Access Compliance Report

Public Rights-of-Way

(Curb Ramps)

Intersection ID: 47968	Main Street: MESA_VERDE_RD	Cross Street: KYRENE_RD	Location: NE
ADA ID: 4C2C6179717B	Ramp Type: PerpDiag	Initial Pass/Fail: Fail	Overall Compliance: No
		Severity Score: 10

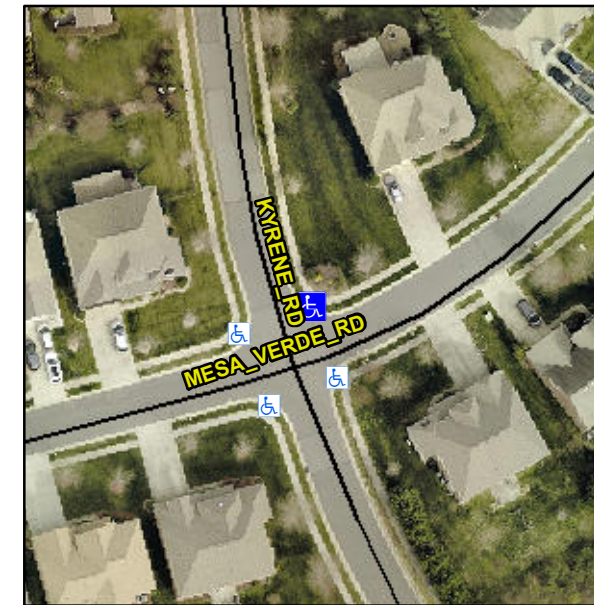
Compliance	Description	Data	Compliance	Description	Data
N/A	Ramp Length (in)	47.0	Yes	Ramp Slope (%)	7.9
No	Ramp Width (in)	46.5	No	Ramp XSlope (%)	4.9
N/A	Flare Type LT	N/A	N/A	Flare Type RT	N/A
N/A	Flare Slope LT (%)	N/A	N/A	Flare Slope RT (%)	N/A
N/A	Flare Traversable LT?	N/A	N/A	Flare Traversable RT?	N/A
N/A	Landing Length (in)	N/A	N/A	DWS Provided?	N/A
N/A	Landing Width (in)	N/A	N/A	DWS Contrast?	N/A
N/A	Landing Slope (%)	N/A	N/A	DWS Length (in)	N/A
N/A	Landing X Slope (%)	N/A	N/A	DWS Full Width?	N/A
N/A	Landing Curb? (Y/N)	N/A	N/A	DWS Offset (in)	N/A
N/A	Shared Landing?	N/A			
N/A	Gutter Ponding?	N/A	N/A	Gutter Slope (%)	N/A
N/A	Gutter Lip Ht (in)	N/A	N/A	Gutter X Slope (%)	N/A
N/A	Painted X Walk1?	No	N/A	Painted X Walk2?	No
	X Walk 1 Direction	To W		X Walk 2 Direction	To S
N/A	X Walk 1 Width (in)	N/A	N/A	X Walk 2 Width (in)	N/A
	X Walk 1 Slope (%)	2.0		X Walk 2 Slope (%)	0.6
	X Walk 1 X Slope (%)	5.0		X Walk 2 X Slope (%)	0.8

N/A	Ramp inside XWalk1?	N/A	N/A	Ramp inside XWalk2?	N/A
	Road Slope (%)	3.4	N/A	Clear Space?	N/A
	Road X Slope (%)	3.4	N/A	Clear Space to XWalk (in)	N/A
N/A	Any Obstructions?	N/A	N/A	Storm Grate/Utility Hazard?	N/A
	Obstruction Type			Storm Grate/Utility Type	
		N/A			N/A
			Yes	Surface Condition? (G/P)	Good

Remove & Replace Curb Ramp With Two New Directional Ramps or Equivalent.

R304.5.1, R304.5.3
